# AUTOCAR PARTS MONTHLY UPDATE

PARTS BULLETIN

\*JANUARY 2008

## **1. INSULATION RETRO FIT FOR WX CAB**

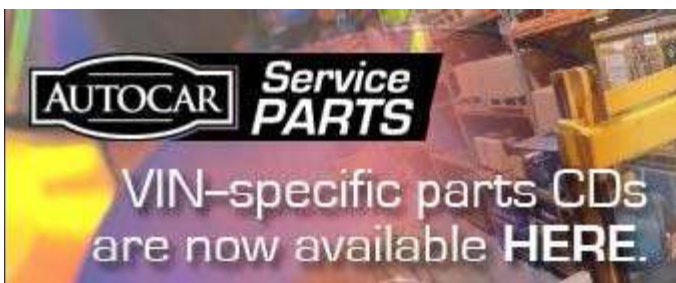
THIS IS A NEW DEVELOPING INSULATION RETRO FIT TO QUIET DOWN THE INTERIOR OF OUR CABS. THIS IS BEING USED IN 07 BUILDS BUT IT SEEMS SOME CUSTOMERS WOULD LIKE TO USE IT ON THE OLD TRUCKS TO HELP BLOCK SOME OF THE NOISE ALSO. IF YOU ARE INTERESTED IN QUIETING DOWN YOUR CAB YOU WILL NEED ONE EACH OF THE FOLLOWING GROUP OF PARTS AS WE WILL NOT BE GROUPING OR KITTING THESE PARTS:

PART NUMBER	DESCRIPTION
A5380007-001	MATTING FLOOR, RH WX
A5380011-001	MATTING FLOOR, LH WX/WX DD
A5380012-001	MATTING FRT FLOOR, LH WX/WX DD
A5380016-001	PLATE, HEEL
A5460011-001	INSUL, TOP TUNNEL, EXT WX/WXR 07
A5460022-001	INSUL, SIDE TUNNEL, LH EXT WX
A5460022-002	INSUL, SIDE TUNNEL, RH EXT WX
A5460023-001	INSUL TUNNEL SLOPE, LH EXT WX/R
A5460024-001	INSUL TUNNEL SLOPE, RH EXT WX/R
